Town of Parker Community Development Department
Development Review Division
Attention: **Stacey Nerger**

Application Type: **Site Plan**
Status: **First Referral**
Application Name: Lincoln Professional Park L1 - Maverik
Case/AP#: **SP21-133**
Referral Received: November 24, 2021
Comments Due: December 27, 2021

Review date: **December 2, 2021**
Plan reviewer: **Randall L. Capra**, rcapra@parkeronline.org
Phone: 303.805.3169

TOWN OF PARKER - FIRE/LIFE SAFETY:	C REVIEWED FOR CODE COMPLIANCE w/COMMENTS
---	--

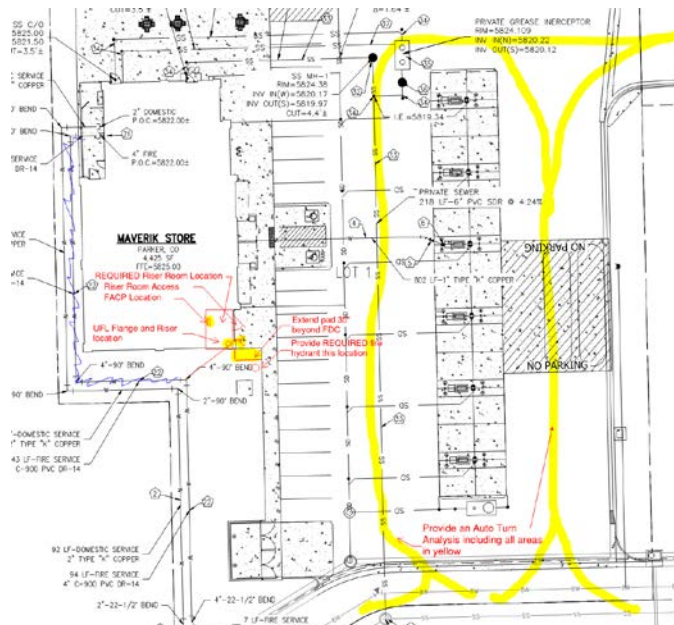
- While the following issue was not addressed (though required in the prior pre-application meeting) the applicant is **REQUIRED** to locate the fire sprinkler control valve room in the southeast corner of the building. See snapshot above for additional information. **Partially satisfied; applicant has not acknowledged this issue with the required response to this letter though the riser room has been relocated to a mutually acceptable location and the utility drawings modified. Not satisfied; applicant has not acknowledged with third submittal. Applicant shall address when resubmitting. Not satisfied; applicant has not acknowledged with fourth submittal. Applicant shall address when resubmitting. Satisfied; after a fifth submittal, the applicant has addressed/acknowledged the comments above.**

6. While the following issue was not addressed (though required in the prior pre-application meeting) the applicant is REQUIRED to provide a room layout ensuring that the fire sprinkler control valve room is sized to accommodate the following:

- Exterior access is required into the riser room with access into the building provided either adjacent to the riser room or through the riser room.
- The FACP will be required to be located in the fire sprinkler control valve room; ensure that the riser room is sized to accommodate the FACP and the riser. A three-foot clearance is required in front of the FACP as well as the sprinkler riser (as well as the three foot 18" to center of FACP/riser... each side.
- The underground fire line shall enter the building and turn up no further than 24 inches from foundation wall; three feet of clearance is required in front of the fire riser.
- The FACP shall be located on an interior wall.
- A 5'x5' pad is required in front of the FDC.
- A sidewalk is required to both the FDC location and the riser room

The riser room layout shall be provided in advance to assure that all requirements are met. See snapshot above for additional information. *Partially satisfied; applicant has not acknowledged this issue with the required response to this letter though the applicant has provided a Fire Riser Exhibit. The exhibit does not address the domestic that is shown to enter the room adjacent to the riser. When resubmitting, address this issue to ensure that there will not be conflicts with the domestic and the fire riser down the road. Not satisfied; applicant has not acknowledged with third submittal. Applicant shall address when resubmitting. Not satisfied; applicant has not acknowledged with fourth submittal. Applicant shall address when resubmitting. Satisfied; after a fifth submittal, the applicant has addressed/acknowledged the comments above.*

7. While the following issue was not addressed (though required in the prior pre-application meeting) the applicant is required to provide a fire hydrant interior to this site; the applicant shall provide a fire hydrant in the island at the southeast corner of the building... as required per NFPA 24, Section 7.2.3 (this section states that a fire hydrant shall be located not less than 40' from the building to be protected. See snapshot above for additional information. Note – Fire hydrants are required at each entry to the side; off Dransfeldt and off of Lincoln with spacing provided as directed at previous meetings. *Partially satisfied; applicant has not acknowledged this issue with the required response to this letter though the utility plan set addresses this issue. Not satisfied; applicant has not acknowledged with third submittal. Applicant shall address when resubmitting. Not satisfied; applicant has not acknowledged with fourth submittal. Applicant shall address when resubmitting. Satisfied; after a fifth submittal, the applicant has addressed/acknowledged the comments above.*

8. The applicant shall provide an auto turn analysis indicating that apparatus can navigate all portions of this site (both sides of the gas canopy); NO PARKING – FIRE LANE signage is required for any portion of the access where the 20-foot clear width requirement cannot be met. This is applicable for the loop around the canopy as well as for each entry. The access on each side of the canopy shall meet his requirement with no portion of the canopy encroaching into the required fire lane access road. See snapshot above for additional information. *Not satisfied; applicant has not addressed/noted/acknowledged with second submittal. Applicant shall address when resubmitting... providing the auto turn analysis in the process. Not satisfied; applicant has not acknowledged with third submittal. Applicant shall address when resubmitting. Not satisfied; applicant has not acknowledged with fourth submittal. Applicant shall address when resubmitting. Note – an auto turn analysis was provided with the fourth submittal though the analysis did not show all the access points noted in previous responses. Satisfied; after a fifth submittal, the applicant has addressed/acknowledged the comments above.*
